**DEFENSE NUCLEAR FACILITIES
SAFETY BOARD**

Staff Report

April 19, 2024

Plutonium Storage Container Fire Testing

Figure A-3. Test configuration showing 3013-container (cylinder on right) with instrument manifold. The manifold extended outside the furnace (not shown).
Image taken from Figure 2-3 of Reference [17].

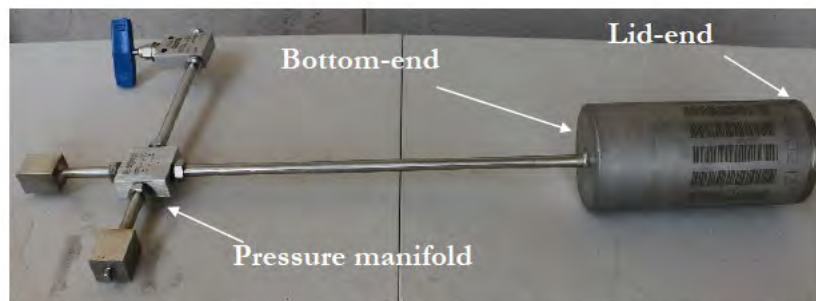
In each test, a 3013-container (the large cylinder in Figure A-3) was connected to an instrumented pressure manifold. The manifold extended outside the furnace, which raised the possibility that water vapor could condense in the manifold during the tests due to lower temperatures in that location. The experiment team recognized this possibility and took steps to avoid condensation of water in the manifold. One of the test plans [6] states: “The pressure tap and manifold are external to the heater assembly and are separately heated and held to approximately 200°C to avoid condensation of the payload water content in the pressure measurement system.”

However, at the pressures observed during most of the tests, a temperature of 200°C is too low to fully vaporize water.³ Exacerbating this issue, experimenters used a heat trace that did not cover the entire manifold, so parts of the manifold were at temperatures even lower than 200°C. Liquid water in the manifold reduced the amount of water vapor available to contribute to pressure in the 3013-container. This reduced pressure likely led to 3013-containers not failing during tests in which they would have failed otherwise. Further, if a container did fail, the failure could have occurred at a lower pressure than it otherwise would have.

Triad discarded the results of sequences 1, 2, and 6 (EPD containers without salt) from further use, due to the possibility of liquid water in the manifold [7]. Triad’s decision to discard three of the five EPD tests was based on the following factors:

The staff team concurs with Triad's decision to discard sequences 1, 2, and 6 for these reasons. However, condensation of water in the manifold may have also affected the pressures of the other tests. Triad provided the following reasoning to support the validity of the remaining seven tests:

However, Triad's reasoning does not eliminate the possibility of liquid water in the manifold during the remaining seven tests. For example, Triad stated that ratios of the observed peak pressure to the expected peak pressure in these full-scale tests were comparable to that seen in small-scale testing. This ratio is relevant because it compares the observed pressure to the theoretical pressure that would be expected if all the water vaporized. If the observed pressure is substantially lower than the theoretical pressure (i.e., a low ratio), it could be a sign that not all the water vaporized. Triad used the results of small-scale testing, where condensation would not have been an issue, to determine what might be a reasonable range for this ratio.

The review team concurs with Triad's judgment that three tests should be discarded. However, the validity of at least two more tests is uncertain. Performing new experiments designed to avoid water condensation in the test manifold would eliminate this uncertainty.

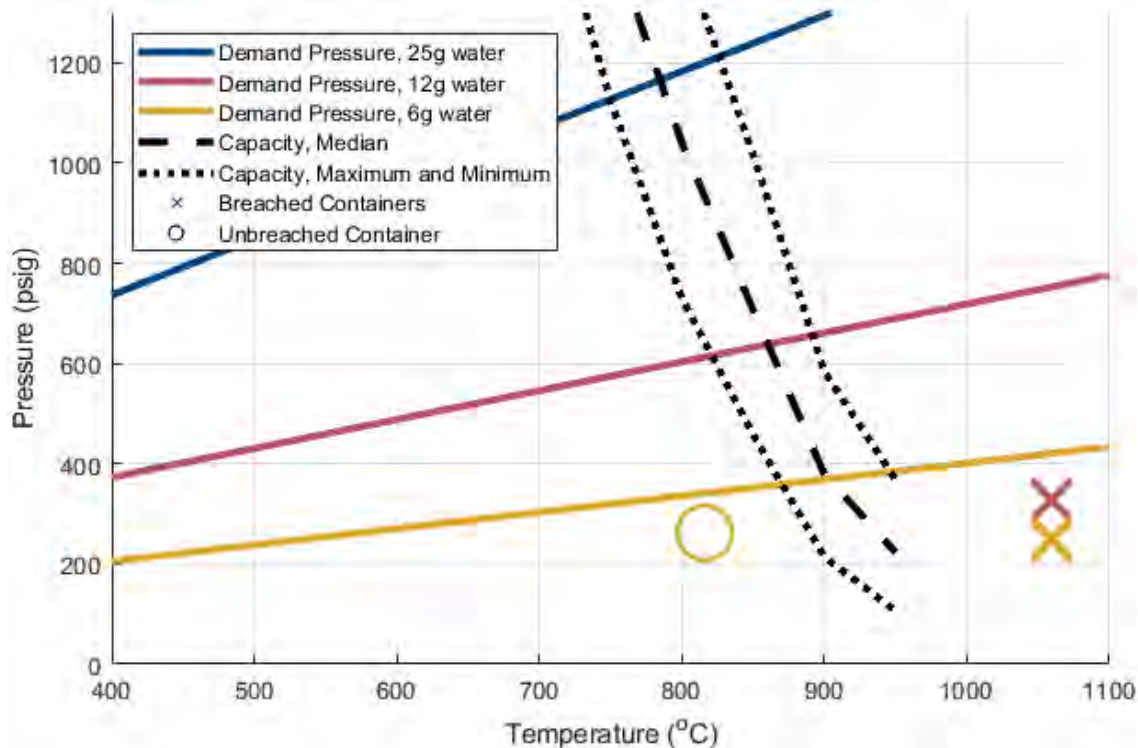
The staff team generated Figure A-4 to examine the conditions of sequence 10. Figure A-4 shows the capacity curves⁴ calculated by SRNS [25], as well as demand curves⁵ calculated by the staff team. Figure A-4 also shows the measured peak pressures for the tests with Flowform containers. As shown, the theoretical demand pressure in a container with 6 g of water (red line) at about 815°C is well below the capacity curves. Thus, these calculations show that sequence 10 should not lead to container breach, which is indeed what was observed. In contrast, the demand pressure would be higher in a container with between 12 g and 25 g of water. This pressure could have exceeded the container capacity in the range of 800–900°C, leading to a container breach.

Accordingly, it is possible that additional experiments in the 800–900°C range could have led to container breaches, and at higher pressures than those the experiment team measured at higher temperatures. For containers with 12 g of water, the experiment team measured peak pressures⁷ between 284 to 332 psig. For containers with 25 g of water, SRNS used extrapolation to estimate peak pressures of 403 and 507 psig for EPD and Flowform containers, respectively [23]. These observed and extrapolated peak pressures are lower than the pressures that theoretical calculations suggest are possible at lower temperatures.

New experiments would be needed to conclusively determine the behavior of containers in the 800–900°C range, given that there are several reasons why the actual behavior would not match the theoretical calculations. One challenge is that, as a container heats up, the temperature of the steel of the outer container (corresponding to the capacity curve) will increase faster than the temperature of the gas inside the container (corresponding to the demand curve). As a result, the theoretical maximum failure pressure indicated by the intersection of the demand and capacity curves may not be reached, but there is still a potential for failure at higher pressures at lower test temperatures. SRNS personnel acknowledged the potential for higher failure
